# Feedback on Karangahape Road enhancements

The Karangahape Road (K Road) enhancement project is a joint project between Auckland Council and Auckland Transport (AT), which aims to preserve the road's unique character and create a street environment that supports the local community and meets the needs of a growing population.

*Image : Proposed layout for Section 4(Upper Queen Street).  
More detailed plans are available on the project webpage.*

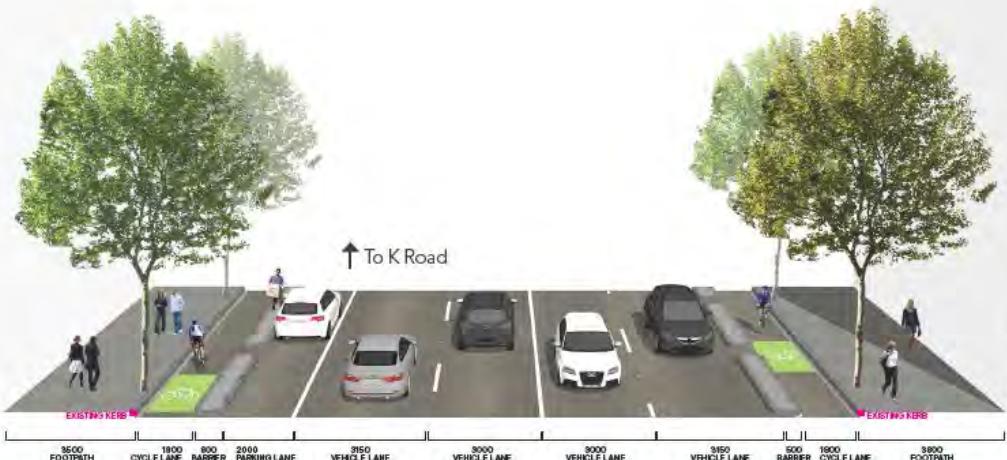
Please note this drawing contains an error. The existing painted median strip in the centre of the road is not shown in this drawing, however, it will be retained. Please see the [project plans](#) for the design for this section.
